AutoGyro Certification Ltd Service Bulletin (Permit)

Title: Calidus upper mast bracket replacement		Release date 30.03.2022
SB-145 Iss1	Related documents Modification: MC-439 CCAR No.: None	Compliance Category:
Applicability		OPTIONAL or RECOMMENDED or MANDATORY
Aircraft type & model: Calidus	Aircraft serial Nos. affected: As required, optional	
The maintenance manual to be referenced is this stated or subsequent issue.		None
<p>This form is the response from AutoGyro Certification Ltd either against a problem found in the product in service requiring a containment or rectification action, or as service information for aircraft modification incorporation. For help, contact RotorSport on 44(0)1588 505060, or email compliance@rotorsport.org.</p> <p>The technical content of this document is approved under the authority of the UK CAA Design Organisation Approval Ref: DAI/9917/06</p>

Title: Calidus mast bracket replacement		
AG-SB-2022-01-C-EN	Effective Date: 05 APR 2022	Compliance Category:
Applicability		A - MANDATORY B - RECOMMENDED C - OPTIONAL
Aircraft type & model: Calidus	Affected Serial number(s): All; aftermarket repair	
The maintenance manual to be referenced is this stated

Solidworks view of the improved attachment between the mast and body.

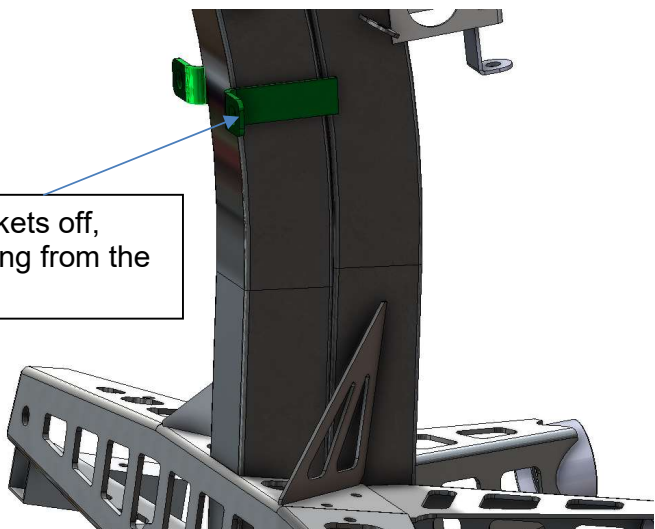
In response to occasional reports of both a crack in the upper mast to body mounting bracket or forward mast in the same area, AutoGyro has developed a repair method to replace the upper mast to body mounting bracket with a separate bracket. This allows mast flexure whilst still providing a secure fixing to the front body.

This also allows easy repair without welding, or in-service upgrade.

Pic. 1

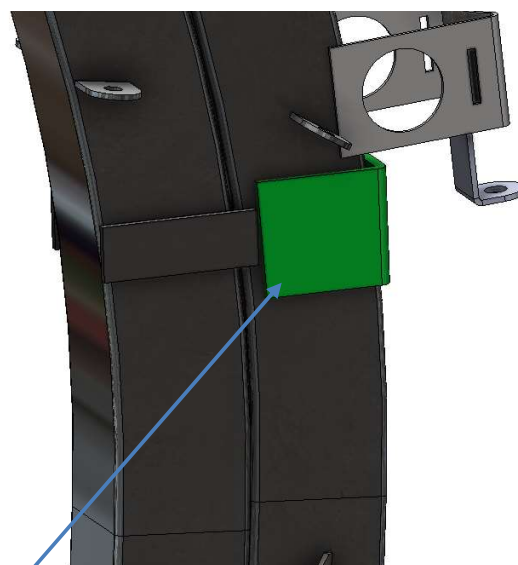
Cut the ears of the brackets off, flush or to 1mm protruding from the mast. Deburr.

Pic. 2

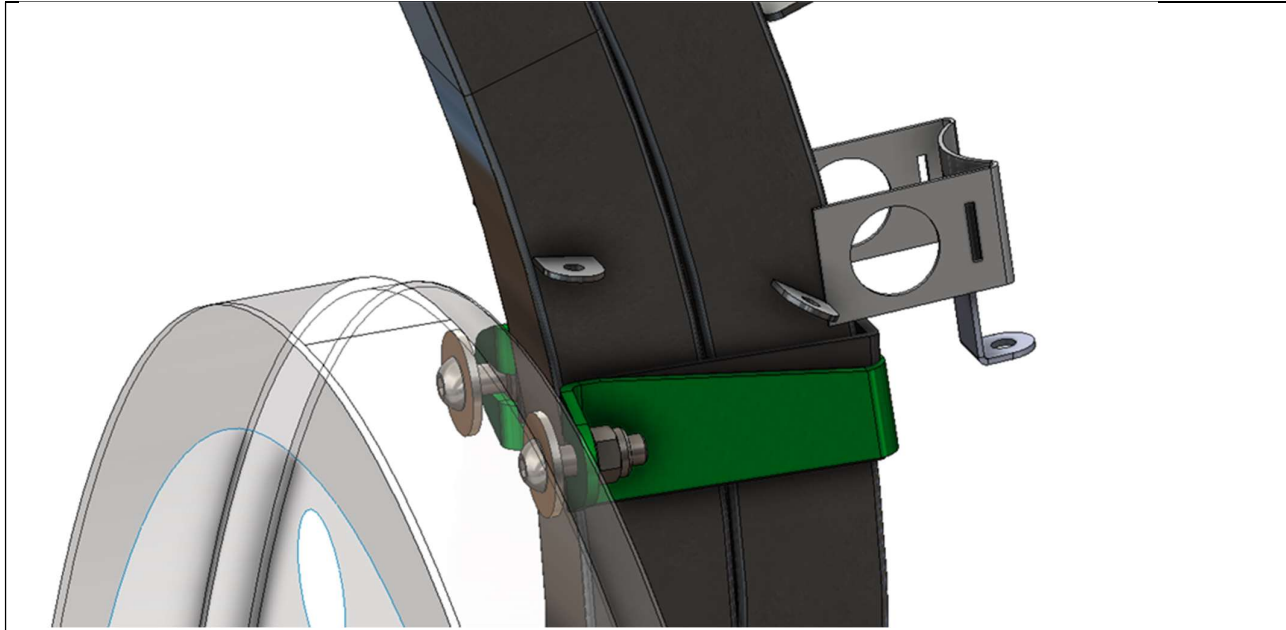
Affix the rubber pad to the mast as shown.

Fit the bracket as shown
